**(a) Planning and Development Act 2000 (as amended) & Planning and Development Regulations 2001 (as amended) (Part 8)**  
**(b) Local Government Act 2001**

In compliance with the provisions of Section 179 of the Planning and Development Act 2000 (as amended) and Part 8 of the Planning and Development Regulations 2001 (as amended) and in compliance with the provisions of the Local Government Act 2001, I hereby notify you that it is proposed to carry out development **at the Point Roundabout, Dublin 1.**

Job Title  
**Point Roundabout Improvement Scheme**

Drawing Title  
**Proposed Scheme General Arrangement**

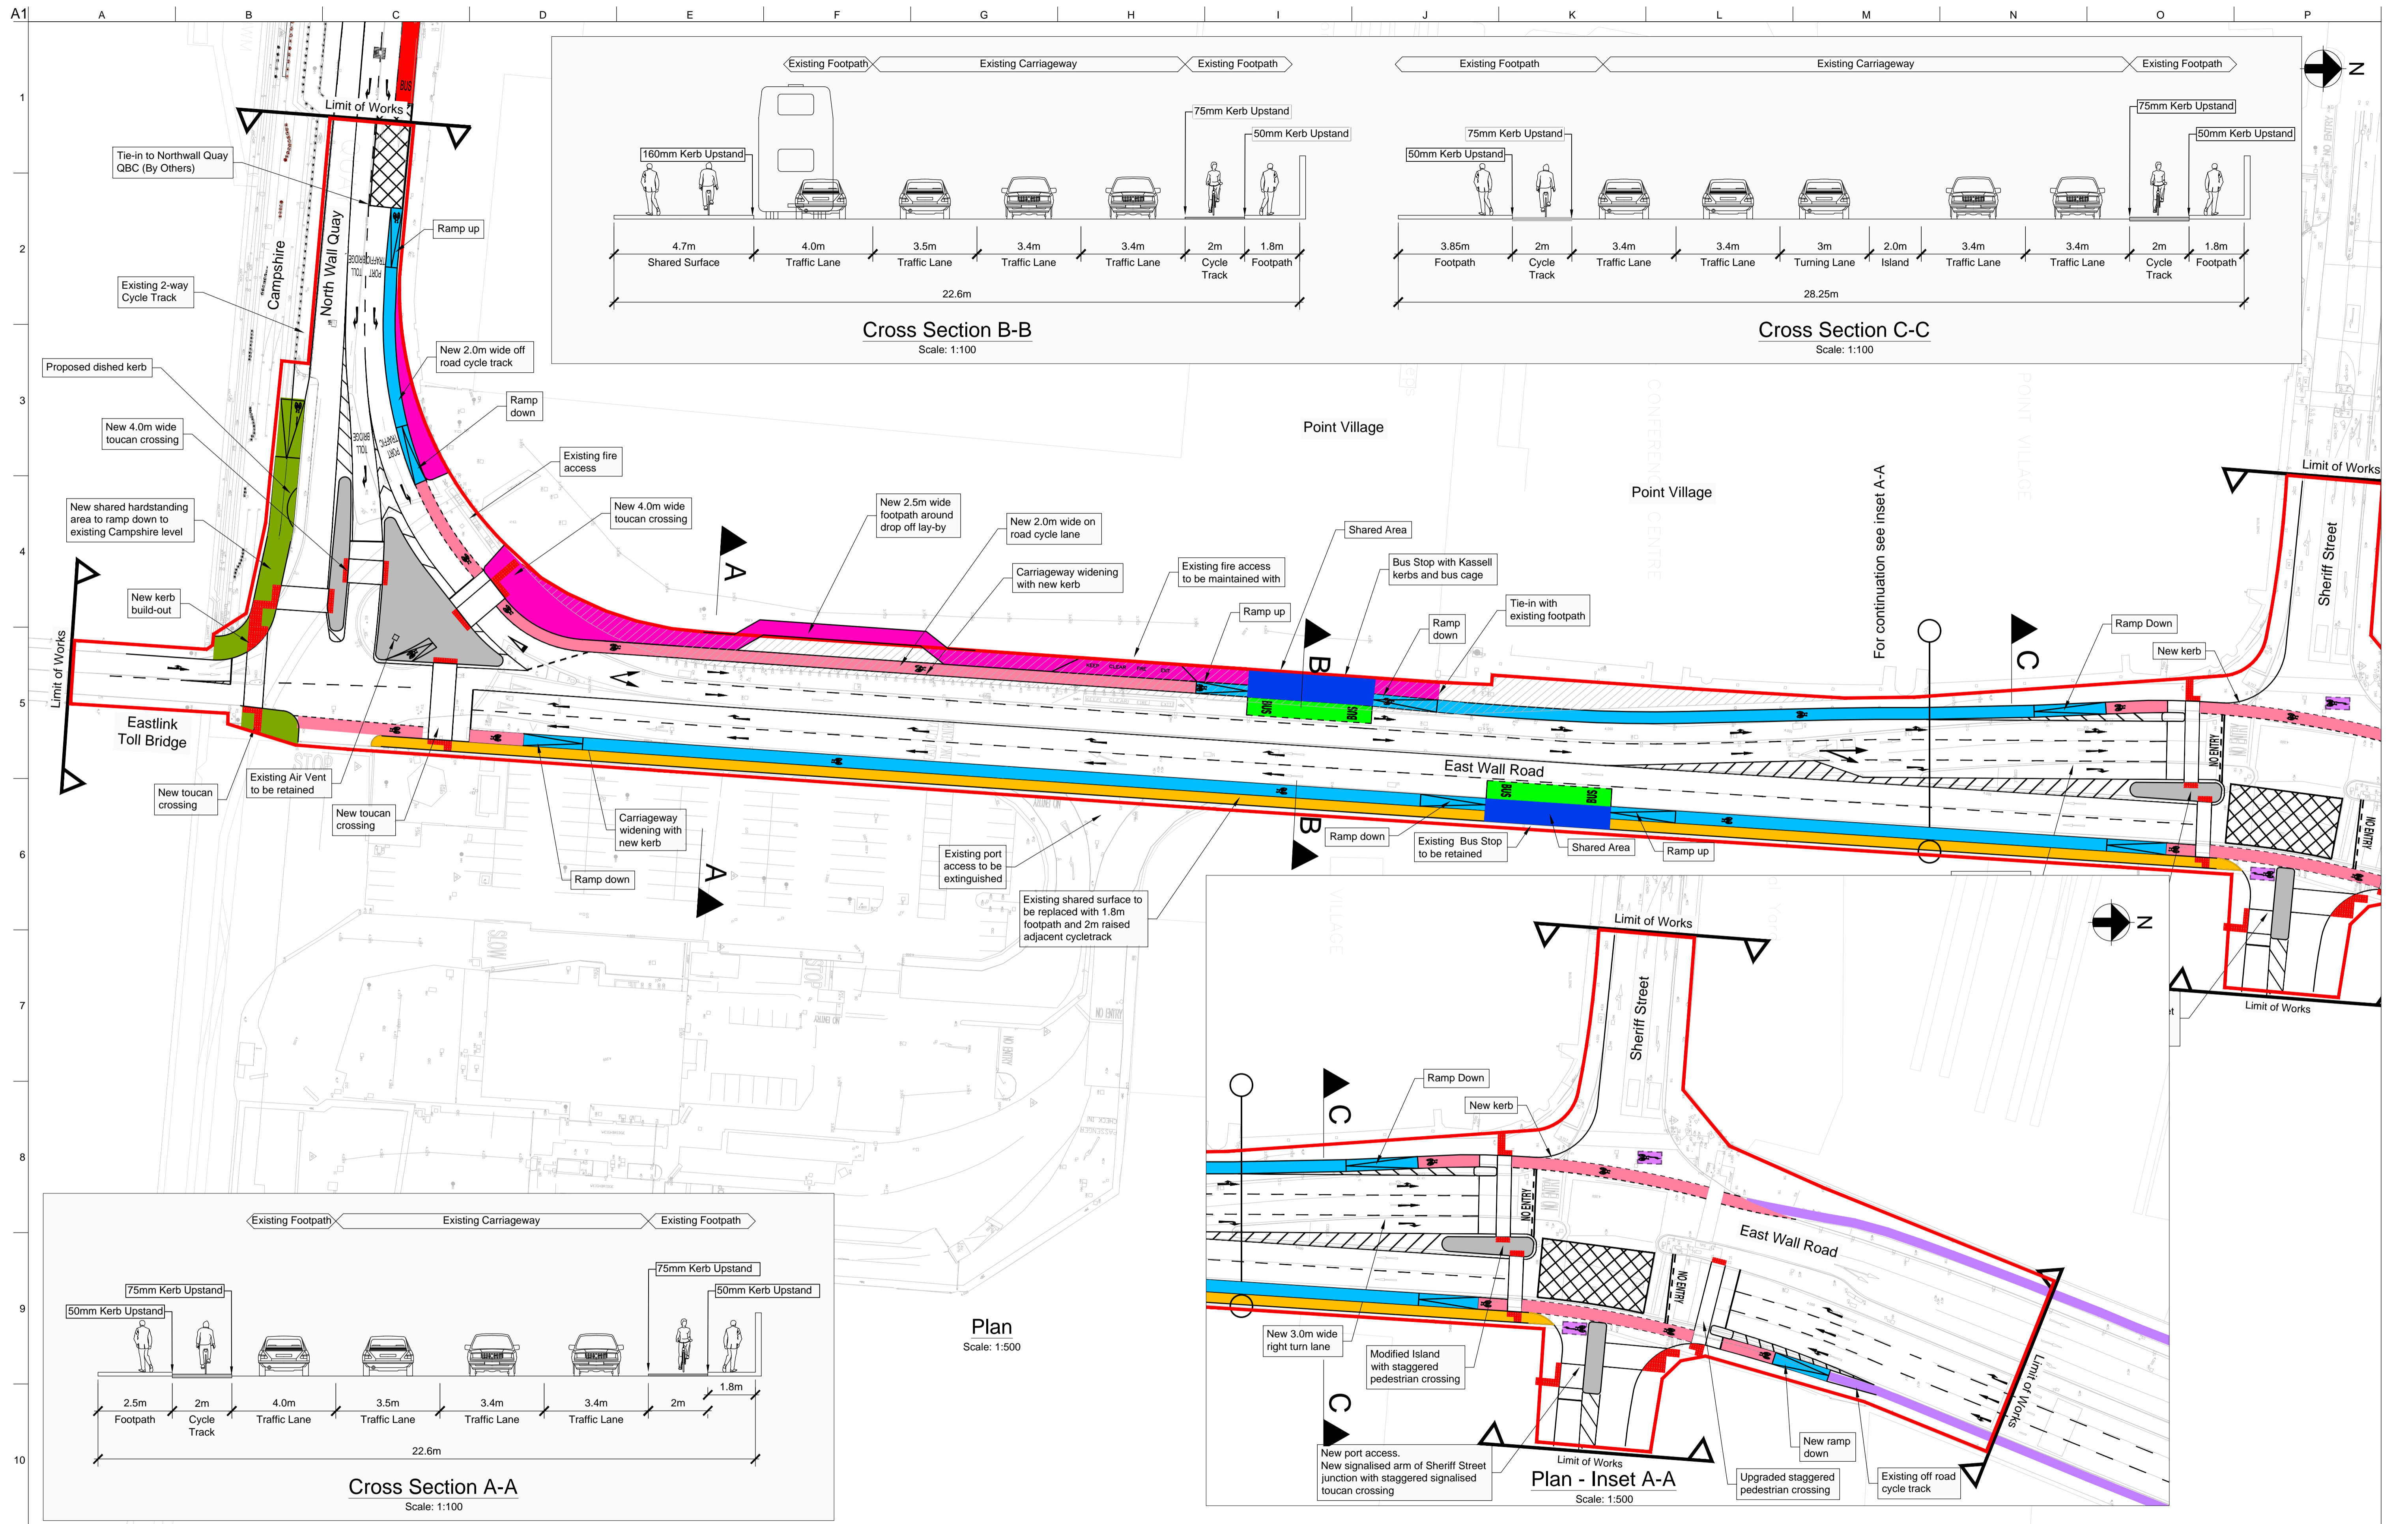
- The corner radius of the slip road from North Wall Quay to East Wall Road is too large (encouraging speeding) and should be tightened.
- The double staggering of the pedestrian crossing on North Wall Quay is not compliant with DMURS and will be most likely be ignored.

- Lack of provision for taxis in the proposals.
- The staggered crossing on North Wall Quay and at the new Port access should be replaced with a straight crossing (as per DMURS)

A number of submissions commented on the corner radius of the slip lane from North Wall Quay to East Wall Road. There was concern that it was too large and that this would encourage high speeds and cause conflicts with cyclists coming from the East-link Bridge.

A small number of submissions commented on the staggered pedestrian crossing on North Wall Quay. There was concern that the design as a three-stage staggered crossing was not adequate for pedestrian movements in the area and that two stage crossing should be provided in its place.

Concerns were raised about the legibility of facilities for cyclists at the Point junction, and in particular the westbound on-road cycle track on North Wall Quay. It is proposed, therefore, to redesign the cycle facilities in this area such that there is more clarity for cyclists. It is proposed to remove the on road cycle track and to allow cyclists coming from the East-link Bridge or from East Wall Road to merge onto a shared space earlier. This shared space will then ramp down to the existing cycle track and Campshire area.

Concerns were raised regarding the facilities provided for cyclists travelling northbound from the East-link Bridge and the potential conflict with vehicles from the left-turn slip lane.

Reducing this corner radius was examined throughout the preliminary design process. It has been designed such that drivers from North Wall Quay have an adequate entry angle and thus a sufficient sightline of vehicular traffic and cyclists coming from the East-link Bridge. It is noted that it is proposed to modify the scheme proposals to further reduce the corner radius as much as possible while maintaining adequate entry angle sightlines as set out in the recommendation of the Roads & Traffic Planning Division report. The slip road will maximise capacity at the junction which has been reduced from the existing situation to provide safe and convenient facilities for pedestrian and cyclists.

The current proposal allows for all traffic and pedestrian movements to take place in three traffic signal stages. A straight crossing would require a fourth 'all green' pedestrian stage. This would reduce the capacity of the junction further, resulting in additional significant queues on all approaches.

As outlined above, on foot of a number of submissions received in relation to the corner radius of the slip lane, it is proposed to reduce the corner radius on the slip lane further to assist with reducing the speeds of merging traffic, while ensuring that adequate sightlines are maintained.

- a) Reduction of the corner radius of the slip lane from North Wall Quay to East Wall Road while maintaining adequate entry angle and sightlines.
- b) Amend the proposed design of the cycle facilities on the southern side of North Wall Quay.
- c) Provision of lay-by along East Wall Road associated with the Block 10C development. (within private lands), including modifications to the cycle track and footpath

d) Slight relocation of the northbound bus stop on East Wall Road to the north to complement the Block 10C development.
